June 20, 2016

**Re: Joint Trades Comments
Air Quality Control, Reporting and Compliance; Proposed Rules
81 Federal Register 19718 (April 5, 2016)
Docket Id: BOEM-2013-0081**

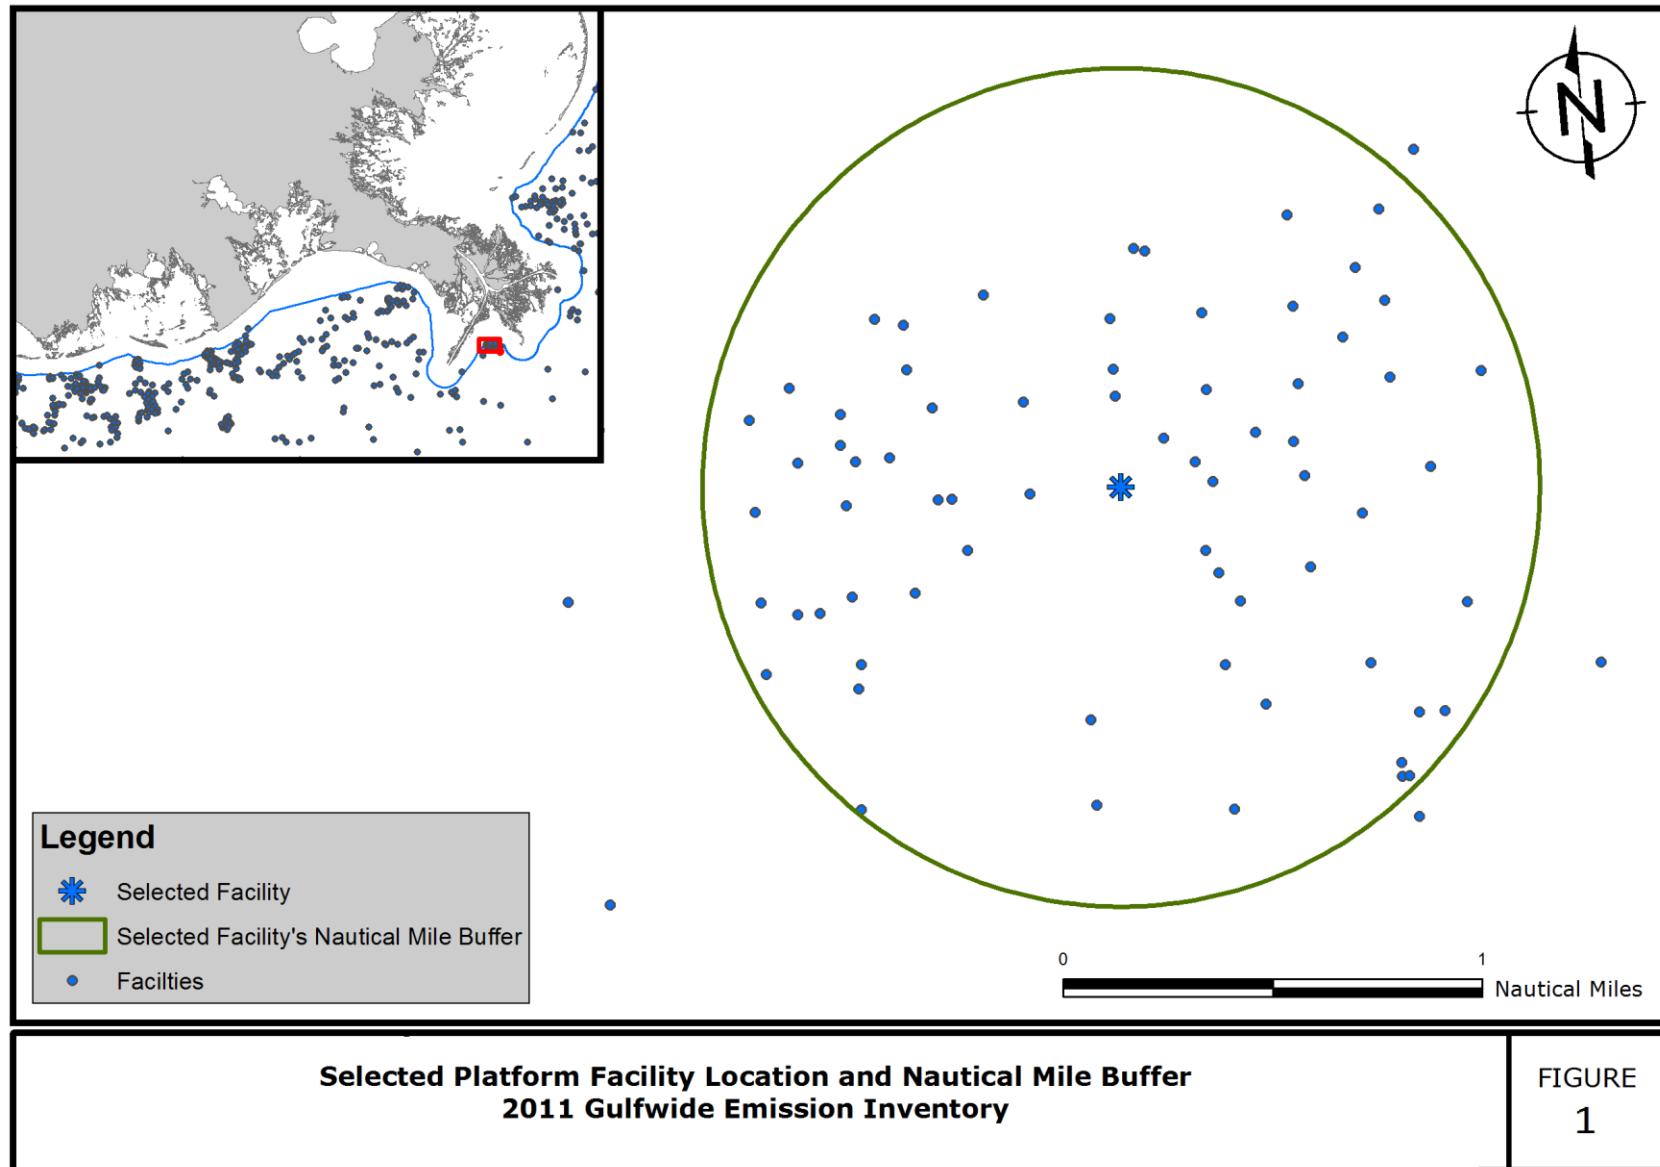
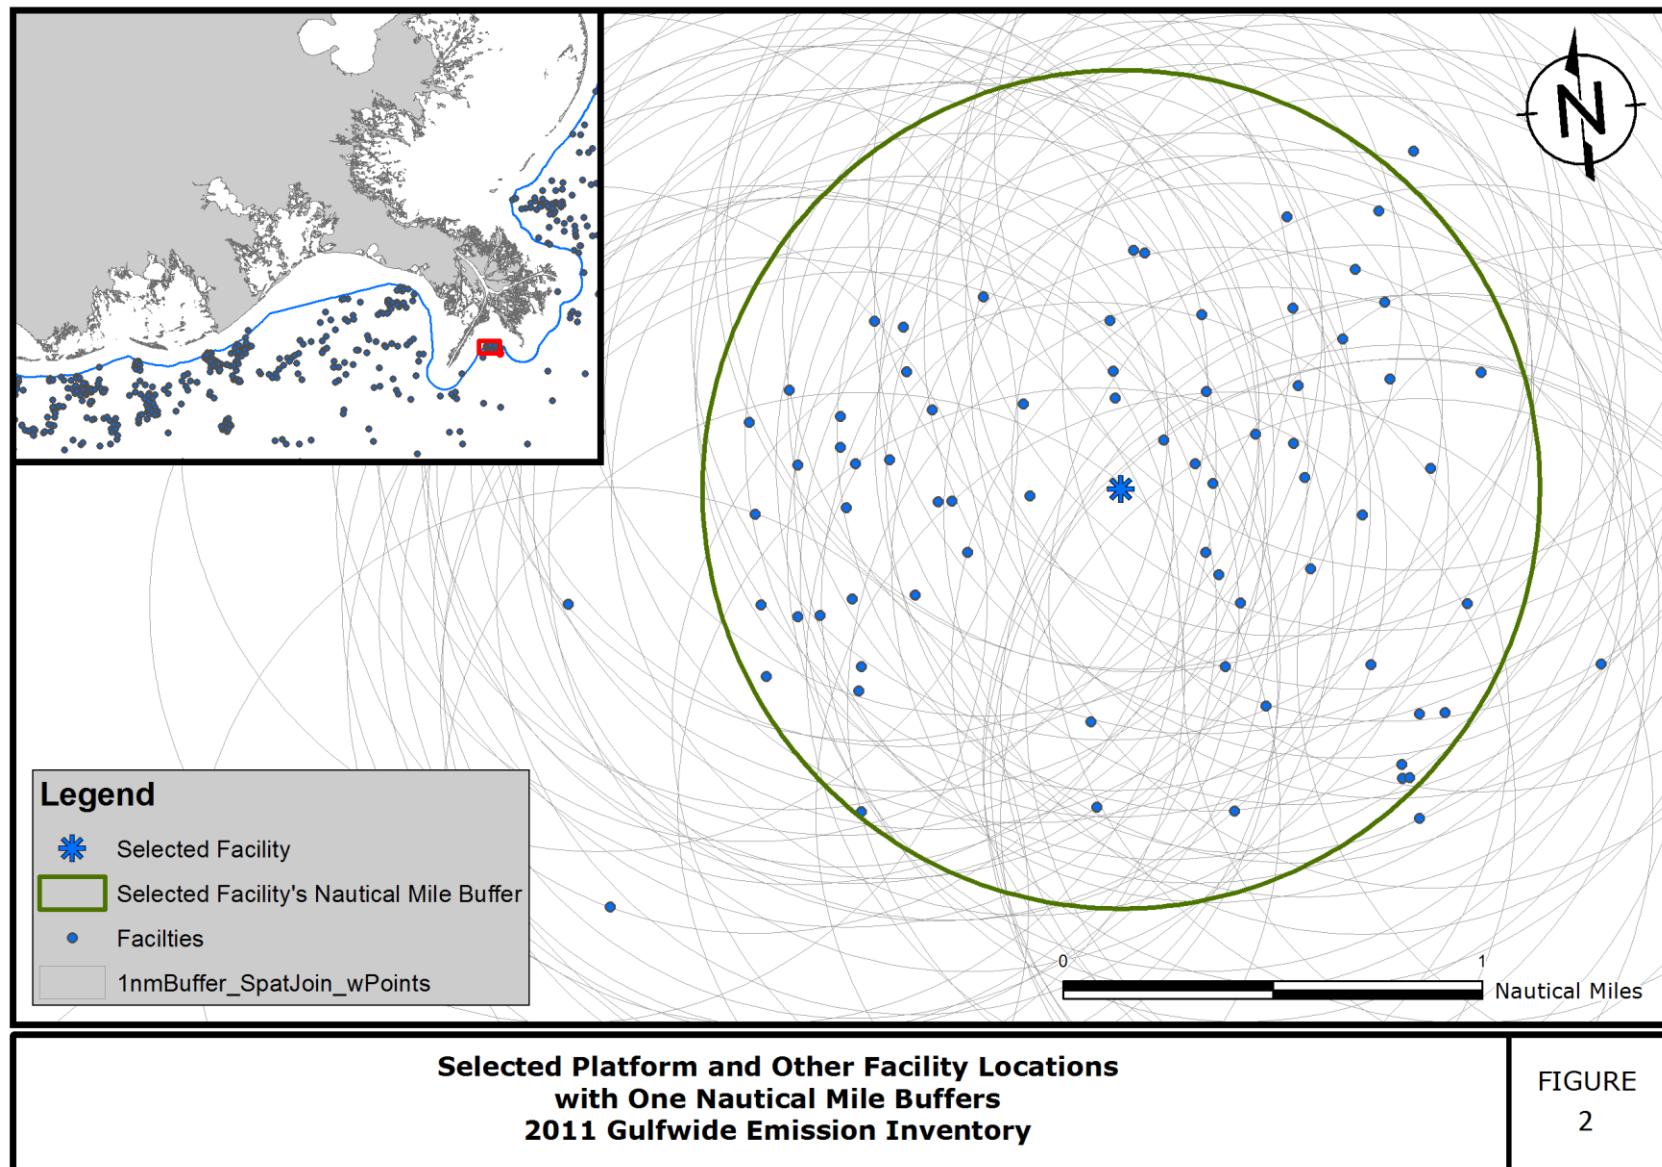
Inventory.²⁸ In Figure 1, the single facility at the center of the circle with a one mile radius could potentially be consolidated with 69 other facilities. Figure 2 demonstrates the potential daisy chain effect by including circles of one mile radius for each of these 69 facilities. Together, these figures demonstrate that, aside from the fact that consolidation of facilities is unnecessary, consolidating facilities within a one mile radius of each other could be impractical and unworkable from a data-gathering and plan approval perspective.

Under the proposed rule, a proposed facility would potentially be required to identify emissions from multiple facilities (and their associated MSC) and to address the aggregated emissions in an EP, DPP, or DOCD. However, implications of consolidations for the existing facilities is not clear. Per proposed § 550.303(d)(4), if a designated operator is required to consolidate multiple facilities, then anywhere a requirement applies to “projected emissions” it would instead apply to “complex total emissions.”

If emissions from the proposed facility do not cause onshore concentrations that exceed a SIL but emissions from the consolidated facility do, it is not clear whether the new facility, the existing facility, or both would implement ERMs. The proposed text in § 550.306(5) refers to selecting reasonable operational controls to “limit your facility’s projected emissions to the greatest practicable extent.” Section 550.307(a), states that “you must apply ERM for the facility.” This would suggest that ERM is only required for the facility described in the plan.

Figure 1 - BOEM Estimates of Benefits and Costs for the Proposed Rule

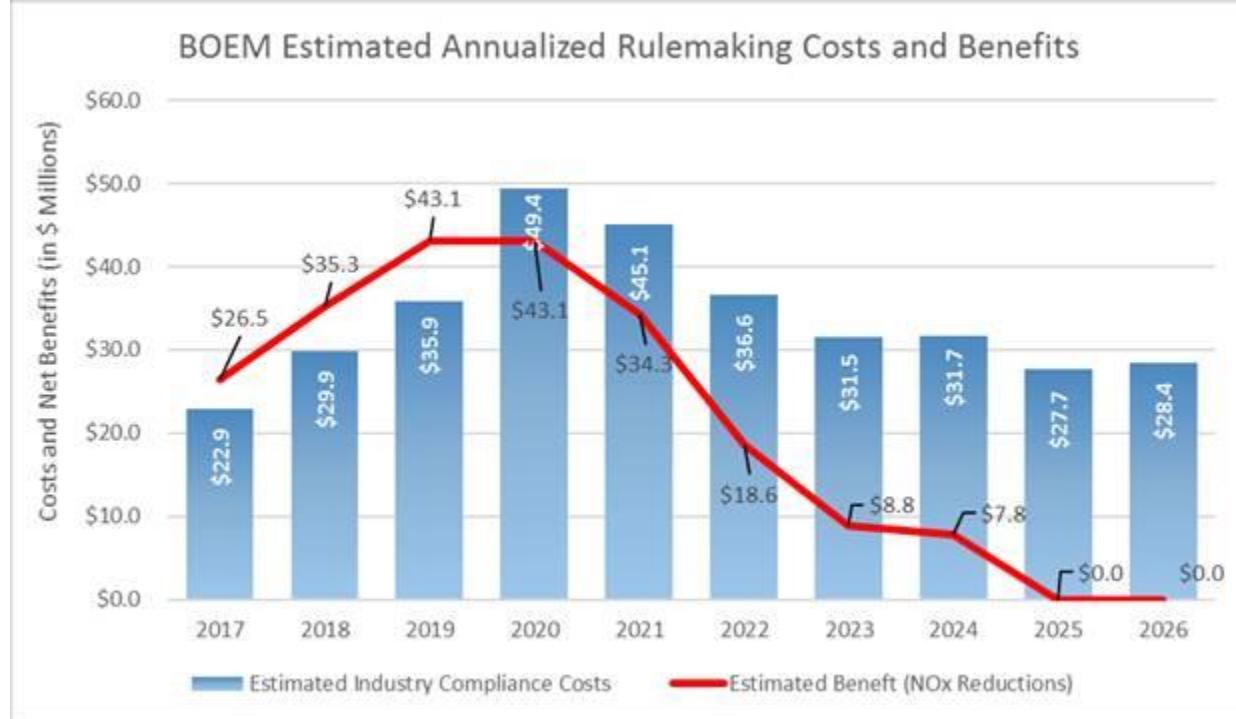
In fact, the agency's analysis shows that over the course of the 10 year window of analysis, the total net cost of the proposed rule approaches \$122 million dollars, compared with a benefit that declines to zero after eight years (see Figure 1).

Based on the cost and benefit data presented in Figure 1, promulgation of the proposed rule would violate OCSLA's mandate of a reasoned balancing of "expeditious and orderly development" and environmental safeguards. It also would contravene the updated Executive Order (E.O.) 13563, which reaffirms E.O. 12866 and further states that agencies must,

Figure 2 –Comparing Estimates of Compliance Costs

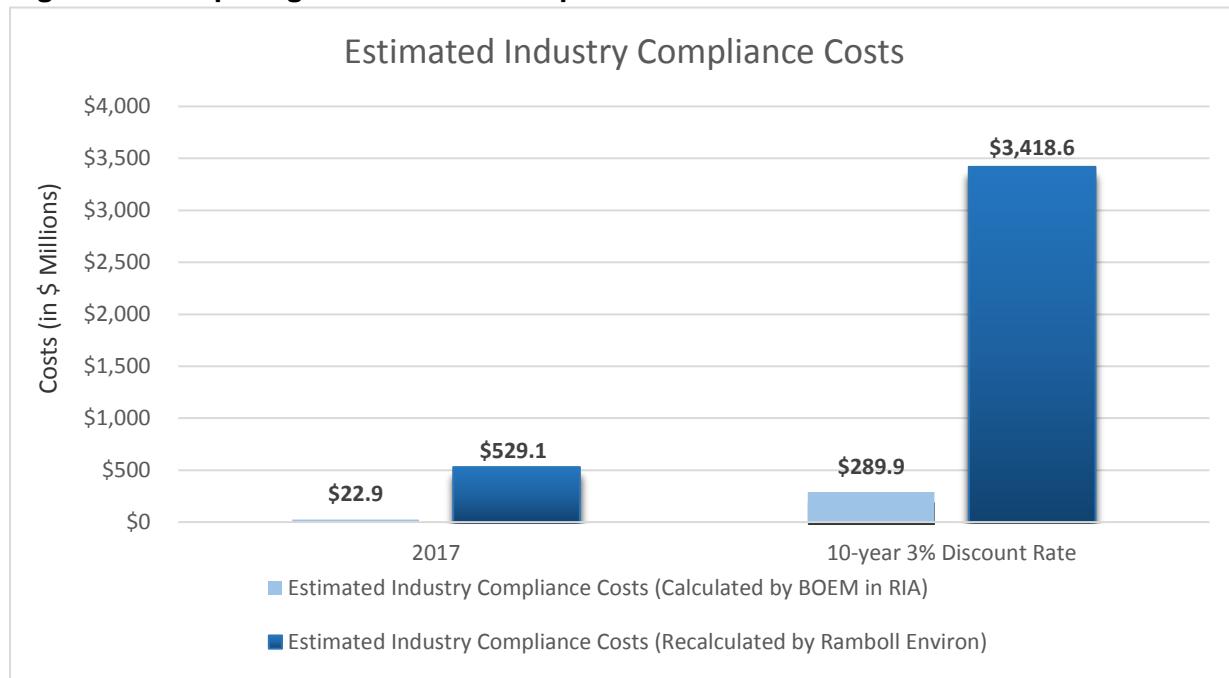
Table 1 shows a comparison of BOEM's calculation of compliance costs compared to the compliance costs as recalculated within this analysis. The first year costs are estimated to be approximately \$23 million by BOEM, and over \$529 million by Ramboll Environ, representing a 23 fold increase. The ten year costs similarly represent a 12 fold increase over the BOEM estimates. The same data are shown graphically in Figure 2.

Figure 3 –Available Air Quality Credits in Louisiana

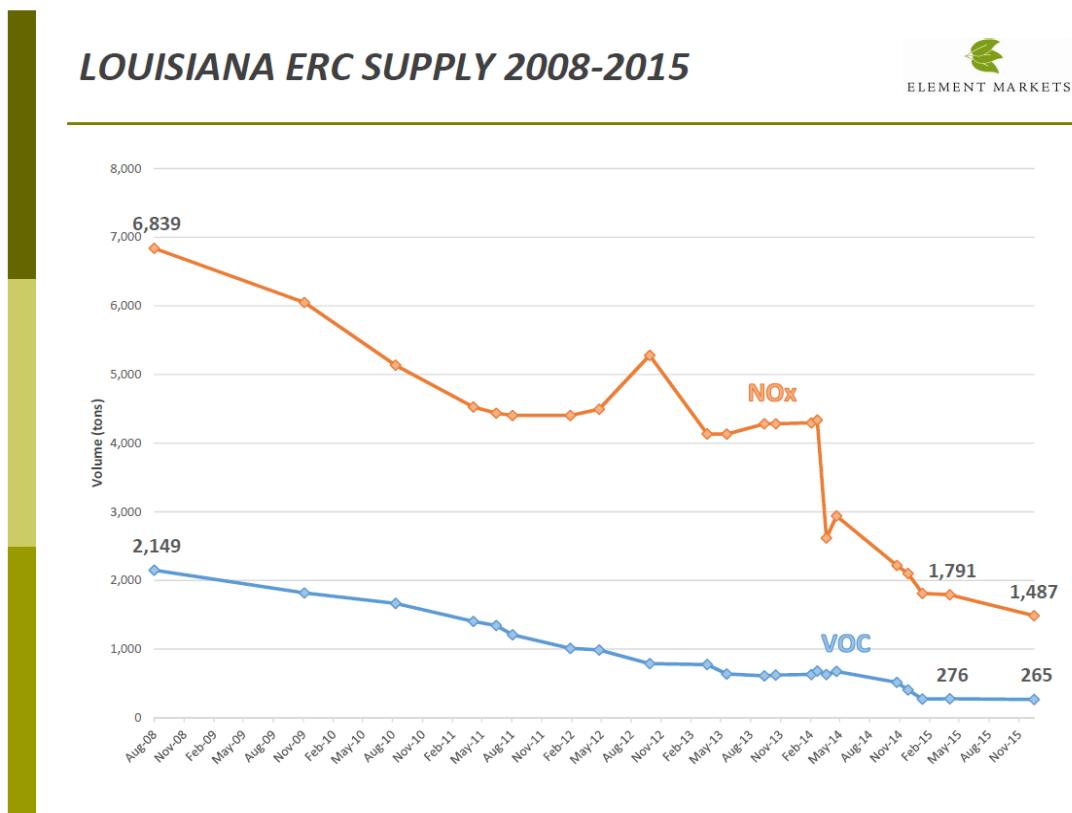
For ozone non-attainment areas in Louisiana, the price of NO_x allocation credits has fluctuated between \$3,000-5,000 per ton for fifteen years, until recent expansions in the non-attainment area. Since the expansions, the availability of credits has dropped by nearly 80 percent, and **NO_x allocation credits have now ranged in price from \$18,000-25,000 per ton** for credits expiring in ten years⁶. Figure 3 shows the dramatic decline in availability of NO_x emission reduction credits (ERC) in Louisiana over the last seven years. The decreased supply correlated to increased difficulty and expense in obtaining credits. If more firms decide to participate in a NO_x trading market due to this rule, general economic theory suggests that demand for credits will increase, the availability of credits decrease, and the price increase. There could be a disproportionately negative impact on smaller firms.
